Salt River Ecosystem Restoration Project

Addendum to the Environmental Impact Report

Humboldt County Resource Conservation District

8 February 2023

FIGURE 2

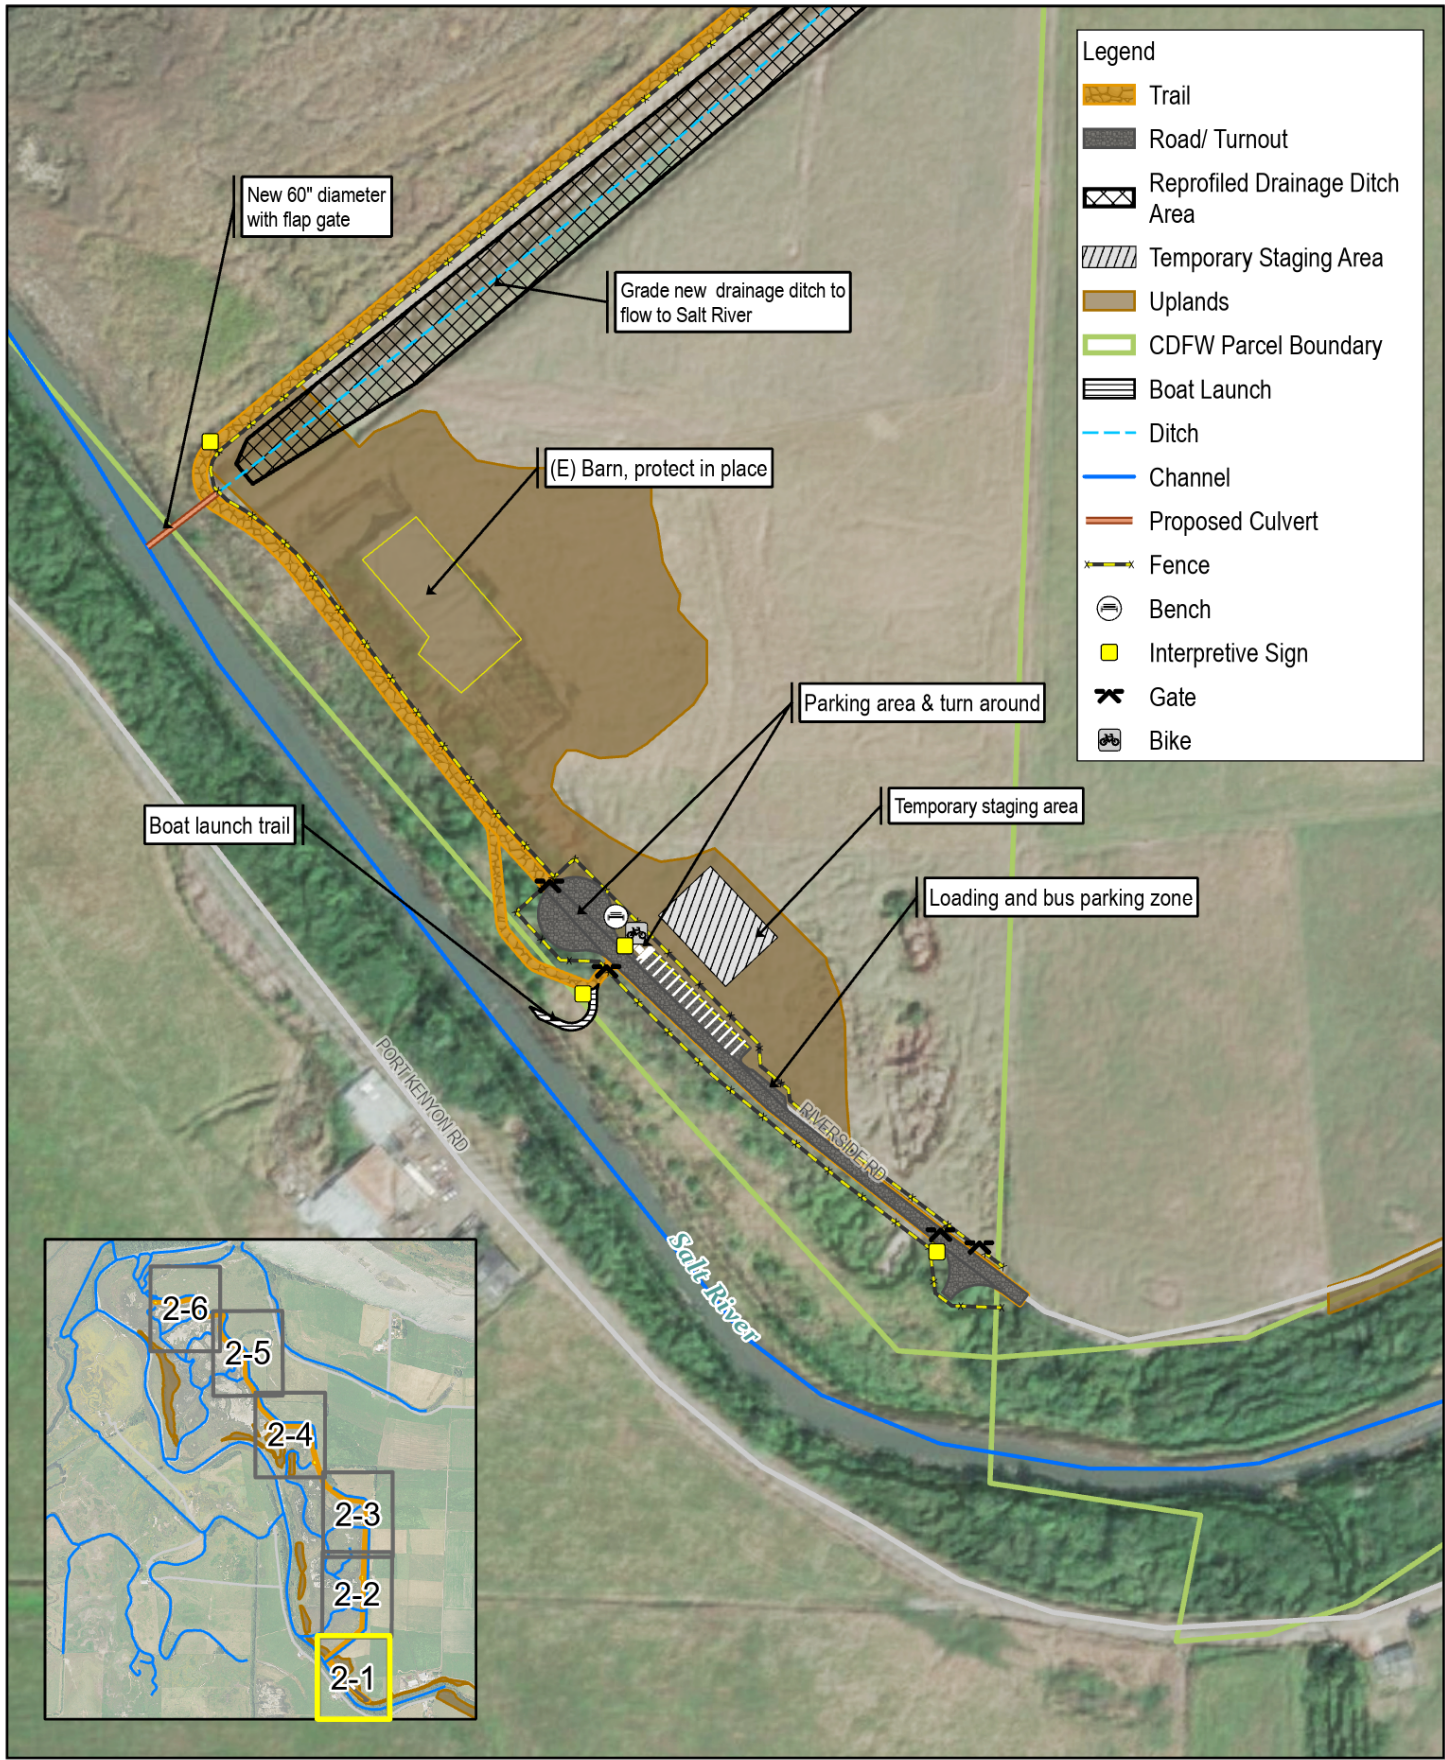
In 2017, the HCRCD engaged the U.S. Fish and Wildlife Service (USFWS) and Kamman Hydrology & Engineering, Inc. to develop a surface water monitoring program on Riverside Ranch. The results of this monitoring from 2017 through 2019 show that during high magnitude (NOAA's California-Nevada River Forecast Center Extreme Flood Level) and extended flood events on the Eel River, water levels on the agricultural lands east of the Riverside Ranch levee were higher than on the estuary side of the levee. This difference in water levels suggests that Eel River floodplain flows are impounded on the agricultural lands by the Riverside Ranch levee and restricted to outflow to the estuary. During lower magnitude flooding (NOAA's California-Nevada River Forecast Center Action Level and Flood Level) drainage conveyance from the agricultural lands to the estuary is limited by the elevation of stormwater infrastructure and the estuary marsh plain channels. In 2021, the HCRCD retained Professional Hydraulic Engineering services from GHD and Michael Love & Associates (MLA) to work directly with USFWS on a Hydraulic Assessment, which included hydraulic modeling, the development of seven alternative design concepts, and the selection of a preferred alternative (GHD 2021). The alternative chosen included lowering the levee from 14.75 feet to 11 feet in two discrete locations, adding two new gated culverts (tide gates) at lower elevations, and constructing approximately 2,300 feet of new and reprofiled drainage ditches (Figure 2, Table 2.2-1).

Two culverts and associated drainage ditches are proposed to be modified to lower peak water levels and floodplain velocities, resulting in improved drainage on and offsite as well as reduced erosion. Lowering of the existing northern drainage channel and installation of a new 60-inch diameter gated culvert discharging into the northern estuary, would reduce the duration of flooding on the northern agricultural fields by 35

hours as well as reduce ponding on the northern agricultural fields by 1.6 feet. Excavation of a new drainage channel that conveys drainage to the south, and 60-inch diameter gated culvert, discharging directly to the Salt River at the levee access road, would reduce the duration of flooding on the southern agricultural fields by 11 hours as well as reduce the peak water levels by 0.5 feet. Therefore, the proposed culvert and drainage modifications would not result in new or more severe hydrology and water quality impacts. The potential impact to hydrology and water quality would remain less than significant with the incorporation of existing mitigation measures

FIGURE 2-1

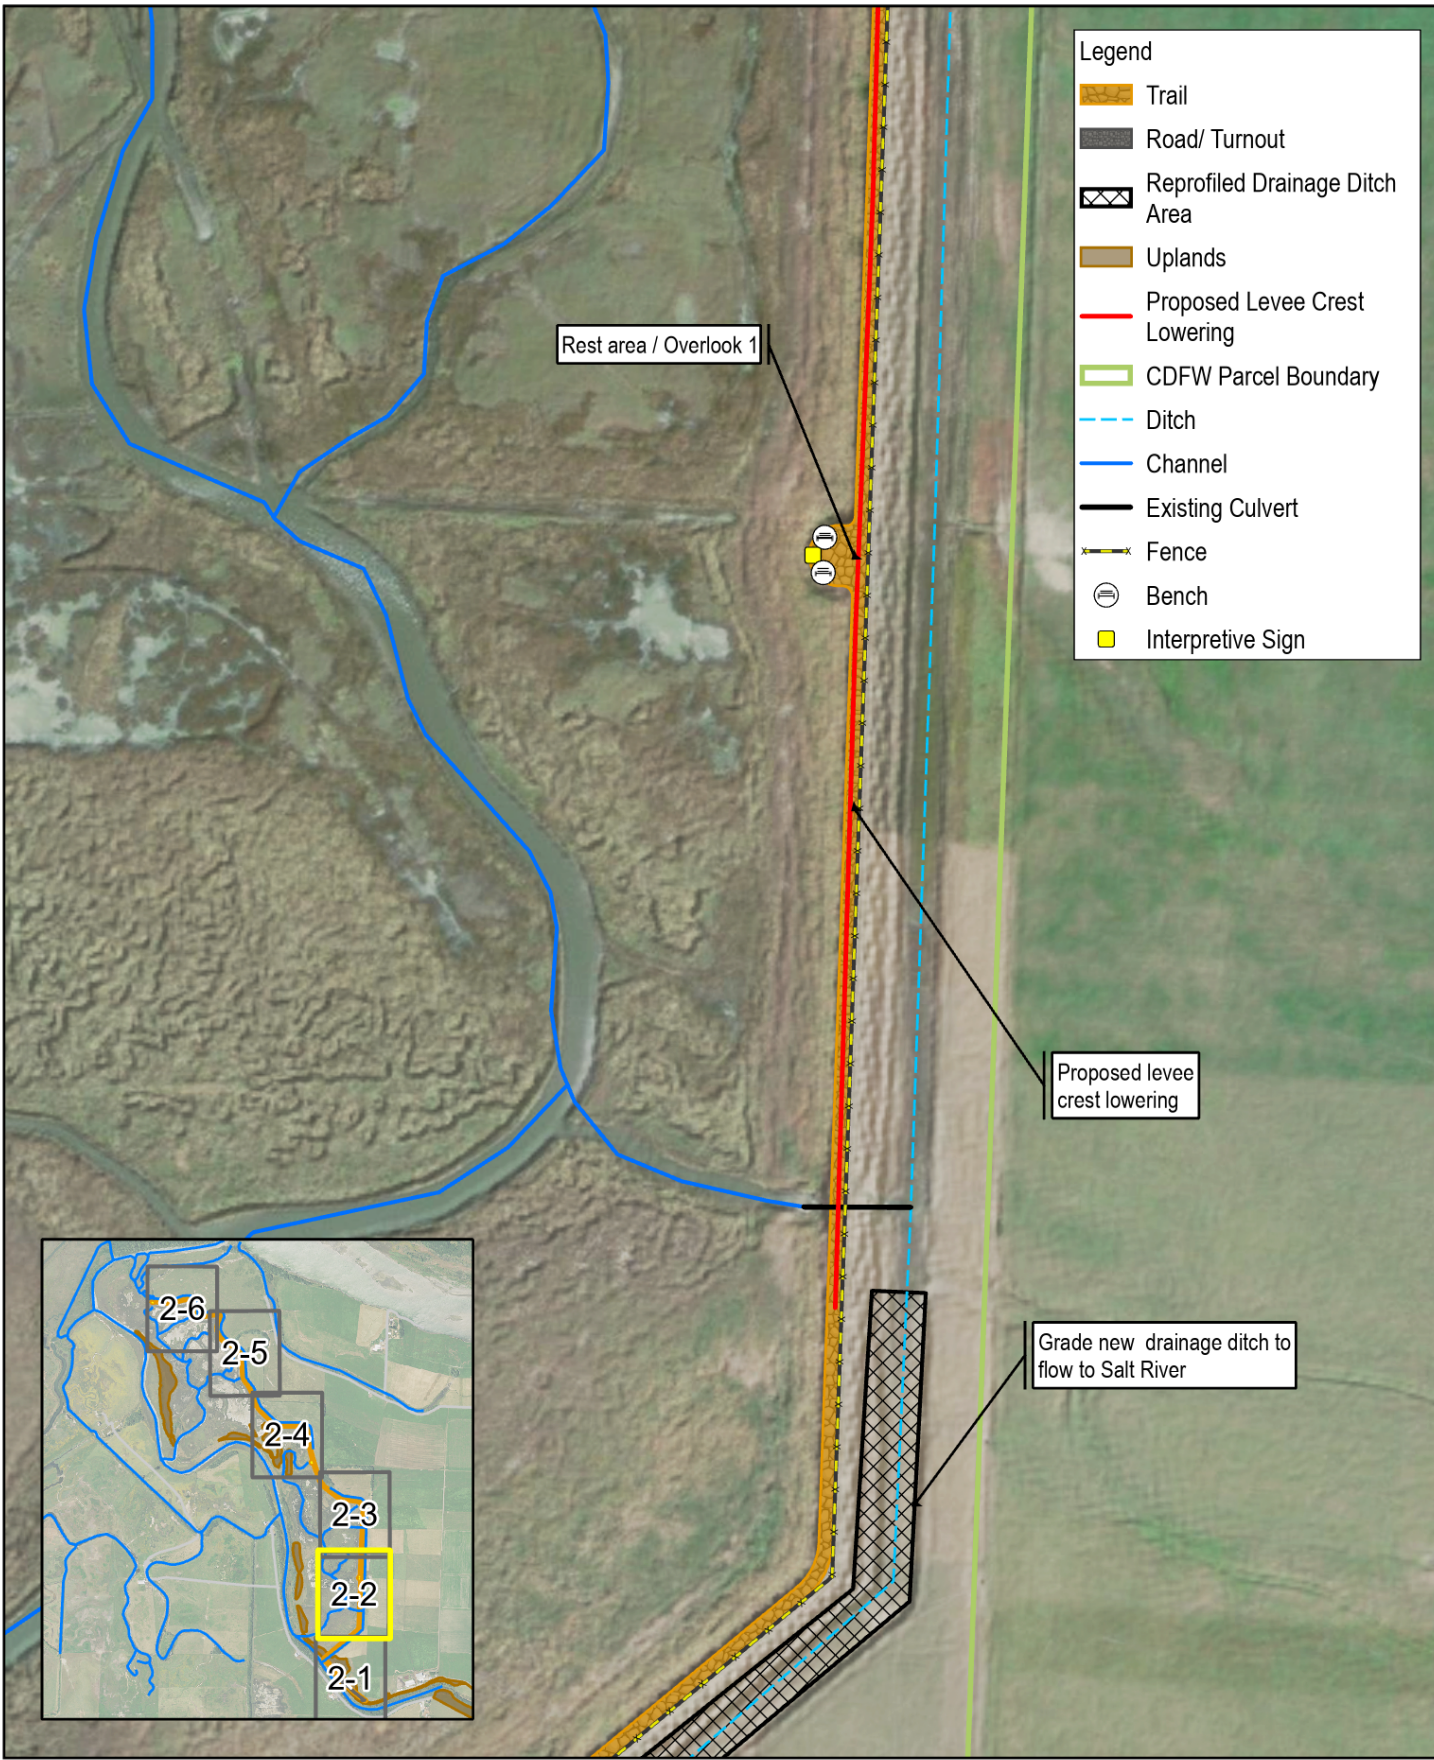
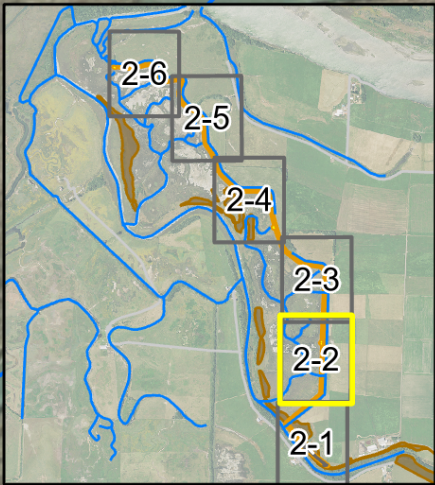
Rest area / Overlook 1

Proposed levee crest lowering

Grade new drainage ditch to flow to Salt River
